CITY OF RICHMOND, VA – PWSID No. 4760100

EPA SDWA Compliance Inspection Report performed July 26, 2022 – July 28, 2022

Attachment A – Areas of Concern

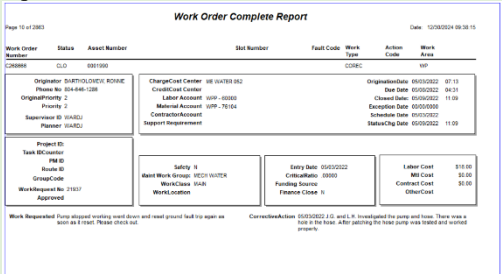
22	Clearwell Pumps	Pumps are corroded and deteriorated at the base, risking a loss of capacity due to deteriorated structures.	EPA observed significant corrosion at the base of Pumps 1, 2, and 3 that move water from the clearwell to the finished water basin.	12VAC5-590-360.A. states that “[t]he owner shall provide and maintain conditions throughout the entirety of the waterworks in a manner that will assure a high degree of capability and reliability to comply with Part II of this chapter. This requirement shall pertain to the source water, transmission, treatment, storage, and distribution system facilities and the operation thereof. The owner shall identify and evaluate factors with the potential for impairing the quality of the water delivered to the consumers. Preventative control measures identified in Part II of this chapter shall be promptly implemented to protect public health.”	The City acknowledges this observation and is addressing this through an O&M project. Pump N-2 refurbishment is nearing completion (see pics 115 and 116). Pumps N-1 and N-3 refurbishment will follow accordingly.
